Item Name: Rear Locker Extender

DART SERVICE INSTRUCTION

TO AMEND INSTALLATION INSTRUCTIONS D350-604 REV. B

REF TCCA STC: SH90-4
REF FAA STC: SR00463NY

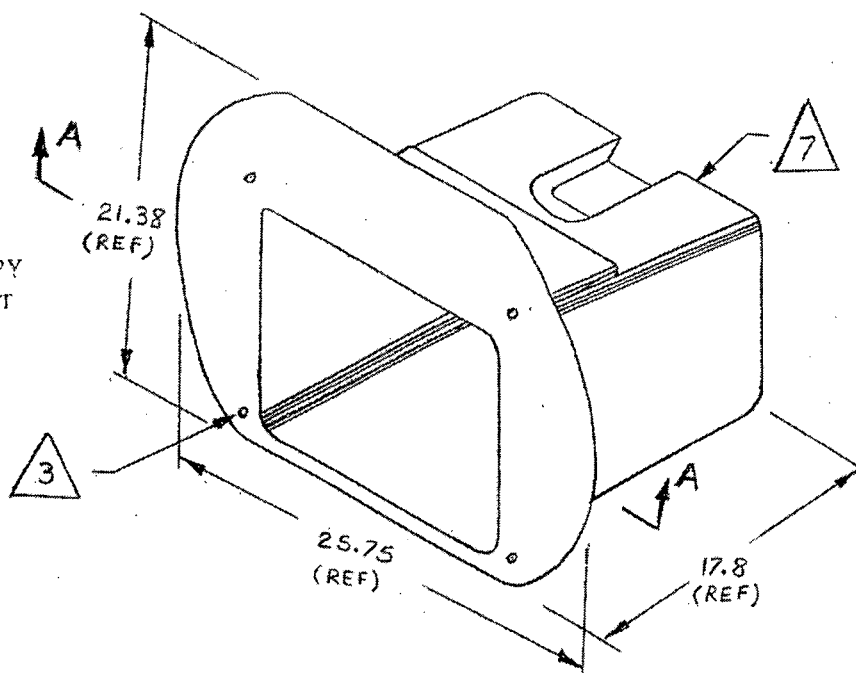
The 2600-4 Camloc Studs may be too short for some installations.

The qty (4) 2600-4 Camloc Studs are replaced with longer 2600-6 Camloc Studs. It is acceptable to install either 2600-4 or 2600-6 Camloc Studs. The parts list of D350-604 Rev. B is amended as follows:

QTY	PART NUMBER	DESCRIPTION
-041		
X	D350-604-041	REAR CARGO COMPARTMENT EXTENDER ASS'Y

IS:

4	2600-6	CAMLOC STUD
---	--------	-------------

WAS:

4	2600-4	CAMLOC STUD
---	--------	-------------
